Eurovent comments on 2025 draft revised VU Regulation – ecodesign requirements for NRVUs

With this position paper Eurovent provides comments on the draft revised Ecodesign Regulation for Ventilation Units discussed at the Stakeholder meeting on 24 April 2025 with regard to Non-Residential Ventilation Units.

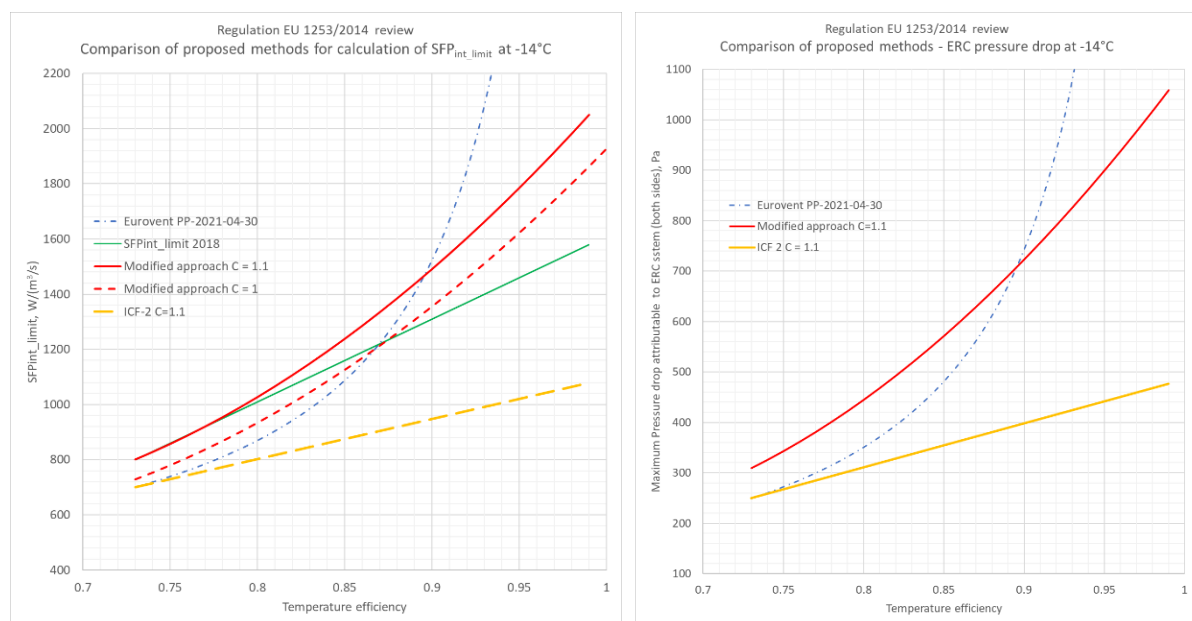
Eurovent and Prof Huber continued to investigate the issue and concluded that the tentatively proposed new E-bonus does not provide a sufficient increase in the SFP_{int_limit} to compensate for a higher pressure drop of more efficient energy recovery components (see yellow curve in charts below).

Furthermore, it does not eliminate the problem of the climate-dependant gap in the SFP_{int_limit} bonus.

- Adjust (decrease gradient) the function of the correction factor E for high efficiency values.
- Calculate SFP_{int_limit} as a function of the actual $\eta_{e,nrvu}$ and not the design outdoor temperature to exclude the influence of climate.
- Adjust the SFP_{int_limit} function so that for a unit without any controls ($C = 1$), it gives limits approx. 10% lower than the current 2018 values, and for a unit with controls corresponding to $C = 1.1$, it gives the same limits as the current 2018 values.

- Eurovent requests adoption of the proposal as per [PP – 2025-04-08](#).

Proposed upper and lower limits of OACF as a function of diameter
Alternative 2 (gives a higher OACF at small rotor diameter.)

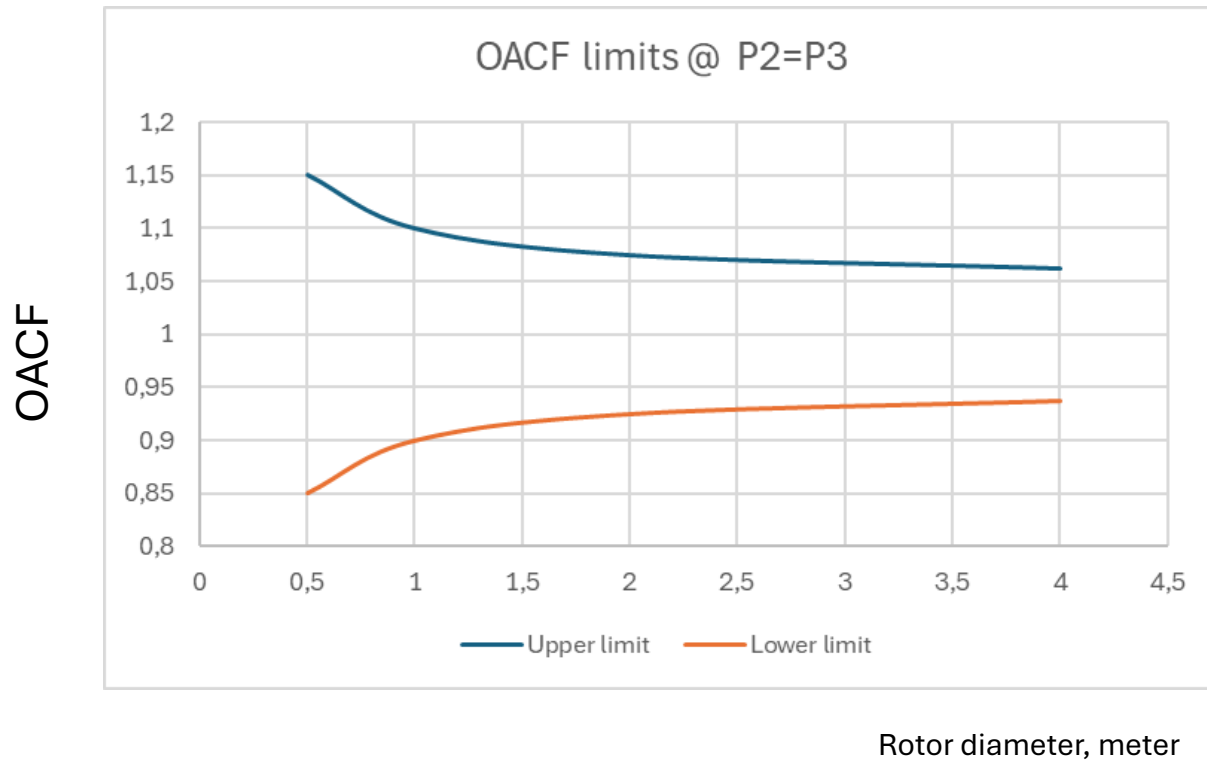
For the purpose of establishing compliance with the Regulation an OACF is calculated with $P_3=P_2$

This means that the pressure difference on the atmospheric side of the rotor will be 2x Rotor pressure drop.

$$\text{OACF limit} = 1,05 + 0,05/\text{Diam}$$

$$\text{OACF limit} = 0,95 - 0,05/\text{Diam}$$
